МЕМО

Subject: Review of Water Right Application G-19003

Groundwater Application Review Summary Form

PUBLIC INTEREST REVIEW FOR GROUNDWATER APPLICATIONS

D. WELL CONSTRUCTION, OAR 690-200

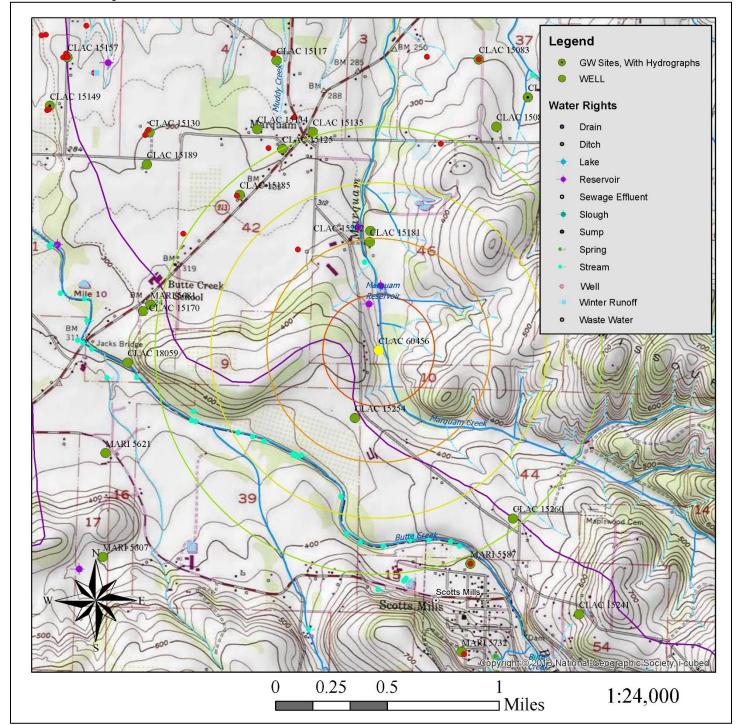
Applicant's Well #1 (CLAC 60456): Based on a review of the Well Report, Applicant's Well #1 seems to protect the groundwater resource.

The construction of Applicant's Well #1 may not satisfy hydraulic connection issues.

D1.	Well #:	Logid:	
D2.	THE WELL does	s not appear to meet current well construction standards based up	on:
	a. \square review of	the well log;	
	b. \square field insp	ection by	;
		CWRE	
	d. \square other: (sp	pecify)	
D3.	THE WELL cons	struction deficiency or other comment is described as follows:	
D4.	Route to the We	ll Construction and Compliance Section for a review of existing w	ell construction.
